<b>To:</b>	Waipa District Council
<b>From:</b>	Angela Brown
<b>Job No.</b>	WPA001
<b>Date:</b>	21/02/2023
<b>Project Name</b>	Private Plan Change 20 – Titanium Park Limited and Rukuhia Properties Limited – Airport Northern Precinct Extension
<b>Subject:</b>	Landscape Review

Figure 4: Existing native planting to SH3 interface recommended to be protected, providing a 'head start' for mitigation along this boundary.

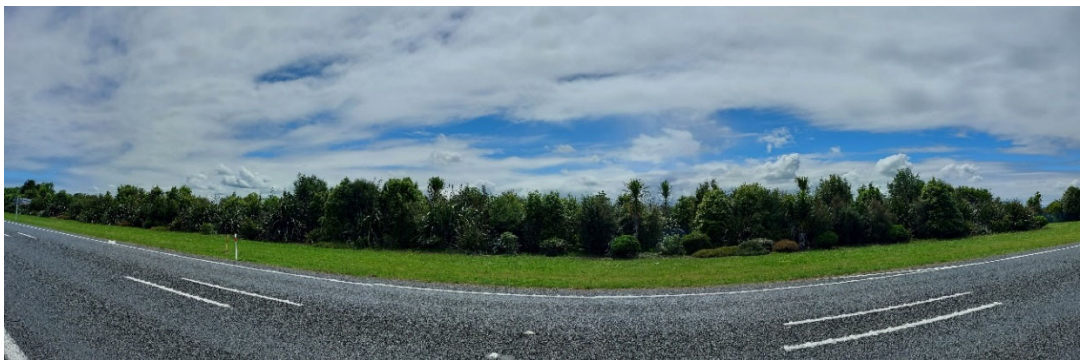
- **5.2.2 Promote the retention of existing specimen trees within the 'indicative landscape feature' as shown on the masterplan or the 5m landscape buffer planting required under the structure plan where they are of good form and can be accommodated within the proposed design. (refer note in section 2.5 regarding this promotion).**

Comment: This is supported. This would cover the existing native buffer planting to State Highway 3 which provides good landscape mitigation for views from the State Highway and the west (Refer image below). This planting continues along the southern boundary of the site and the airport land to Middle Road and it is recommended that this planting is also protected. Further trees around the homestead could not be determined on site but appear to be well established.
